SERVICE BULLETIN

No. 547

Piper Aircraft Corporation

Inspection of Stabilator Tip Rib

END VIEW OF STABILATOR TIP RIB (Left Shown - Right Opposite)

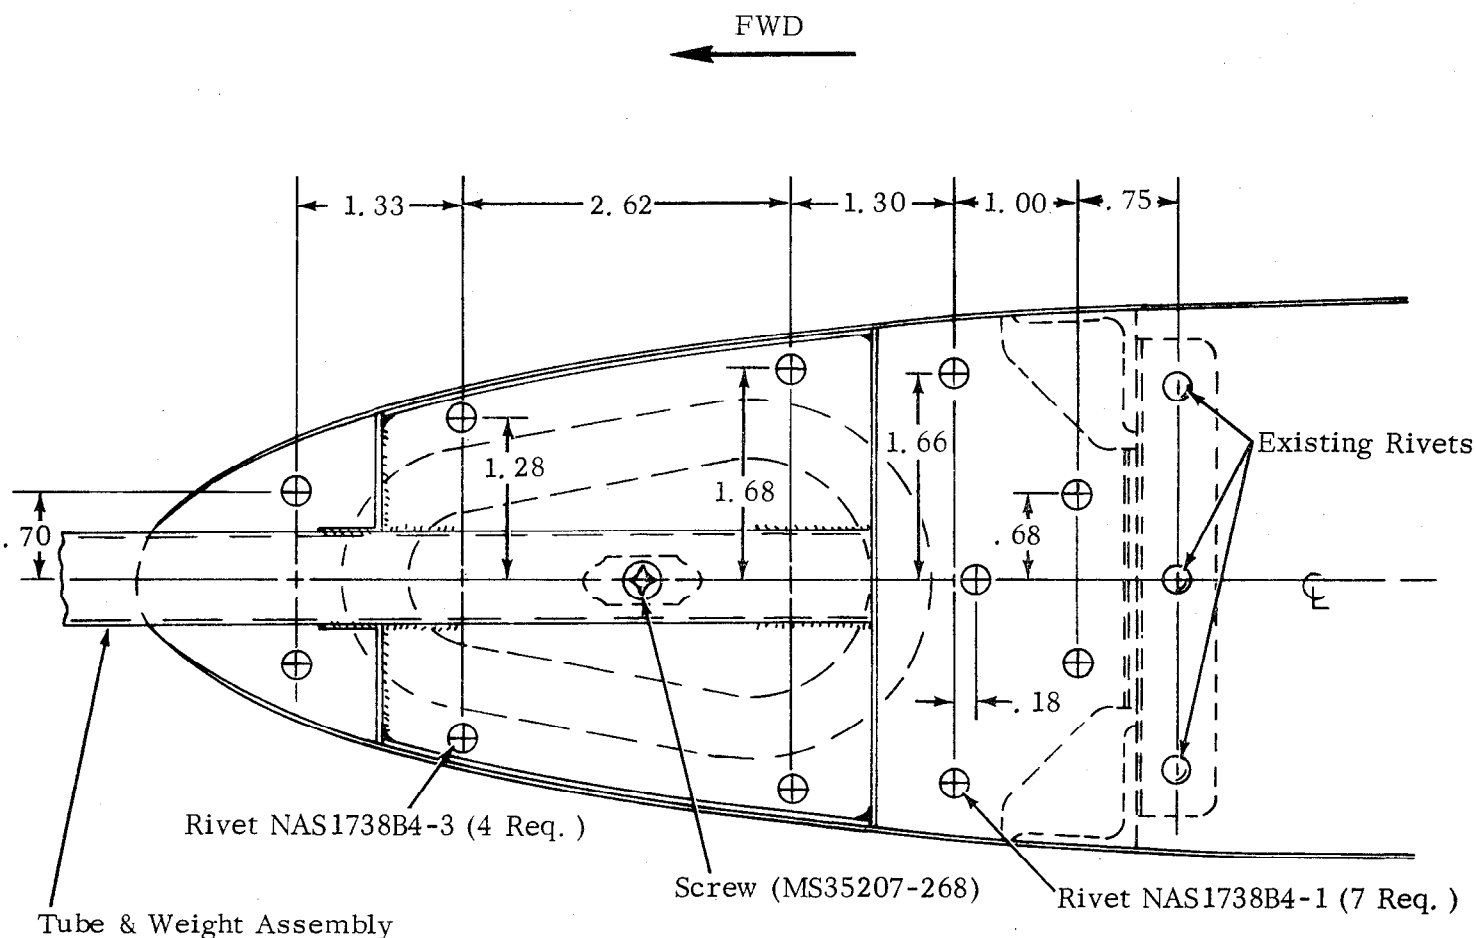
Purpose: Resulting from the inspection specified in Piper Service Bulletin No. 540 dated January 4, 1977, it was found that certain stabilator tip rib rivets and/or the stabilator tip tube and weight assembly attachment screw may be missing. Although no failures have been reported as a result of this condition, inattention to this matter could lead to cracking in the stabilator tip rib area.

This Service Bulletin provides instructions to inspect the stabilator tip rib area to determine that the correct attachment hardware is installed and specifies proper hardware to be installed, if necessary (refer to attached sketch/instruction sheet for an illustrated view of this area).

1. Remove tip assembly from left and right stabilators.
2. Inspect forward end of stabilator ribs to determine if five rivets are installed aft of the tube & weight assembly attachment plate, two rivets installed forward of the attachment plate and a screw installed thru the square tube welded to the attachment plate.

4. If screw and rivets are missing from either stabilator, install new hardware as follows:
 - a. Install MS35207-268 screw (P/N 411 537) thru the square tube and into the anchor nut as shown.

- b. Locate and drill eleven .144 holes as shown above.
 - c. Install four NAS1738B4-3 blind rivets (P/N 522 883) at the attachment plate and seven NAS1738B4-1 blind rivets (P/N 522 881) aft and forward of the attachment plate.

- d. Reinstall tip assembly and make proper logbook entry of stabilator rivet and screw installation per Service Bulletin 547.
